**ADDENDUM NO. 1  
TO THE**

**GARDENDALE AND VILLAGE PARK WEST PRESSURE REDUCING STATION (PRS) REPLACEMENT PROJECT**

June 10, 2024

## **ADDENDUM NO. 1 DRAWING REVISIONS**

G-2

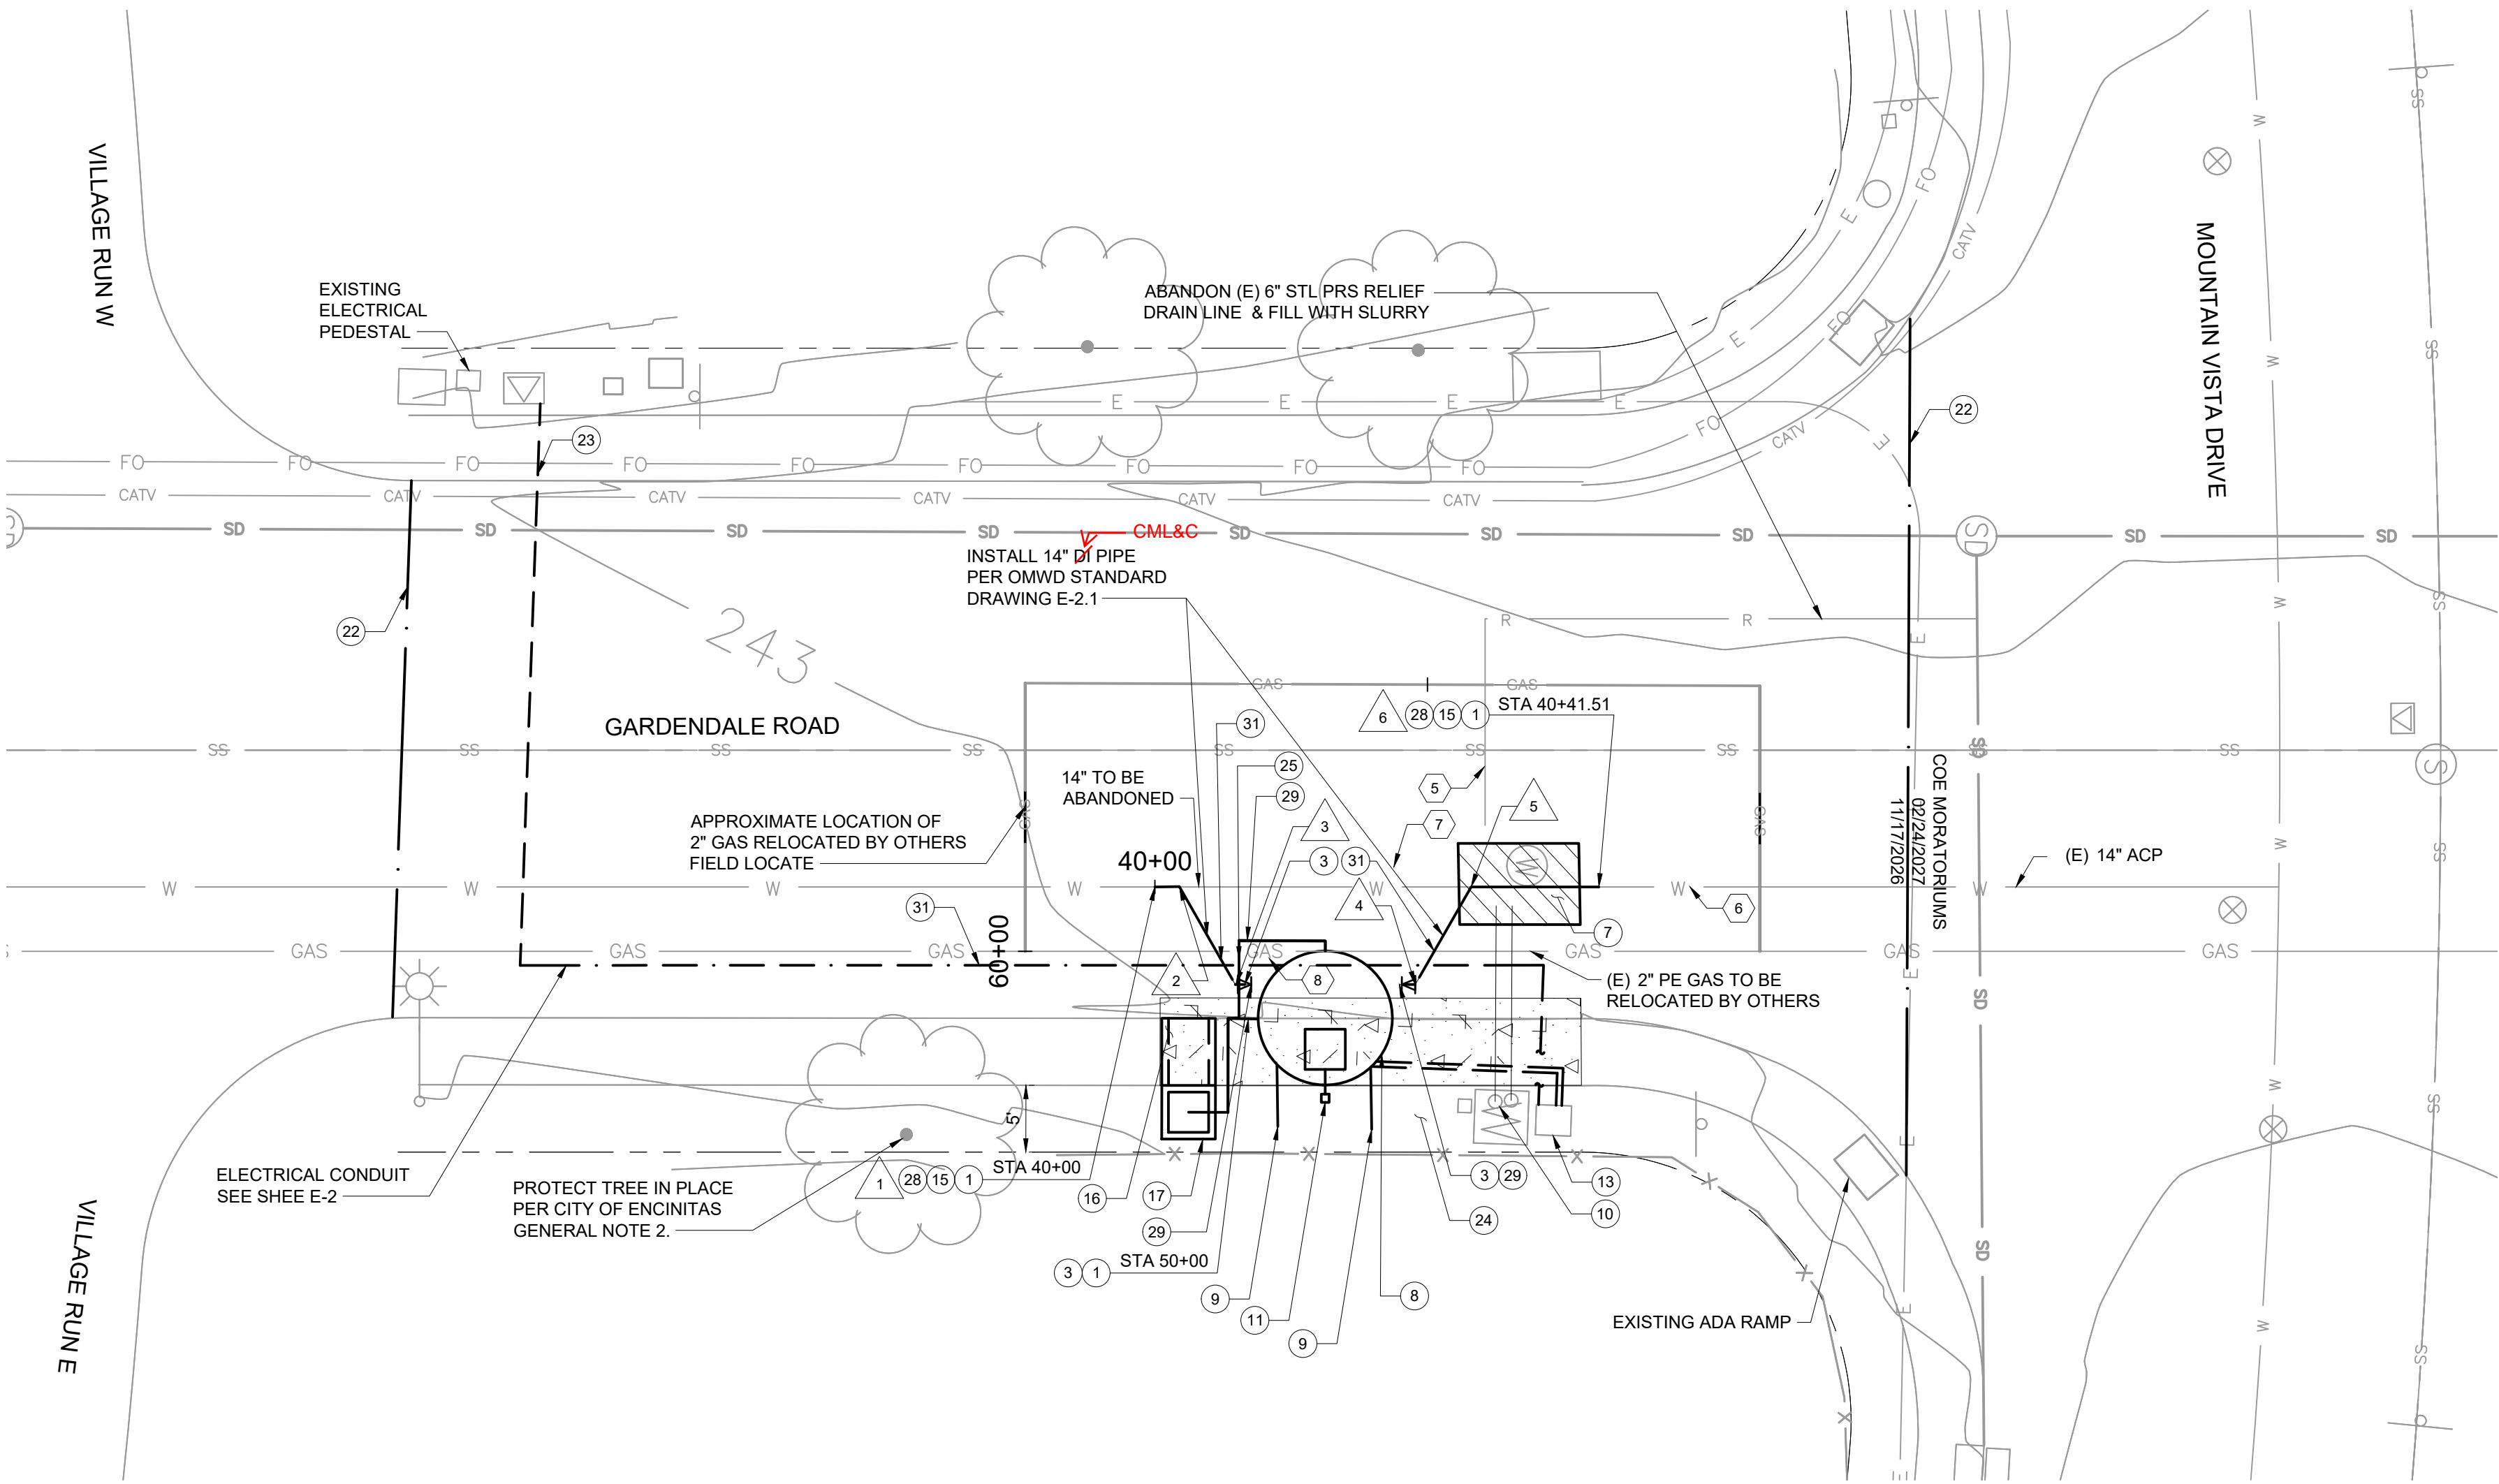
1. Drawing G-2 General Notes; **REVISE** per attached Drawing
2. Drawing C-1 Village Park West PRS, Wandering Road 10" Waterline Improvements; **REVISE** per attached Drawing
3. Drawing C-2 Gardendale Road 14" Waterline Improvements; **REVISE** per attached Drawing
4. Drawing C-3 PRS Piping Profiles I; **REVISE** per attached Drawing
5. Drawing C-4 Curb Outlet Sections; **REVISE** per attached Drawing
6. Drawing C-5 PRS Piping Detail I; **REVISE** per attached Drawing
7. Drawing C-6 PRS Piping Detail II; **REVISE** per attached Drawing

\*OF SPECIAL NOTE, ALL DUCTILE IRON PIPING HAS  
BEEN CHANGE TO CML&C; SHOP DRAWINGS  
REQUIRED FOR SUBMITTAL PER OMWD STANDARD  
SPEC 15061.
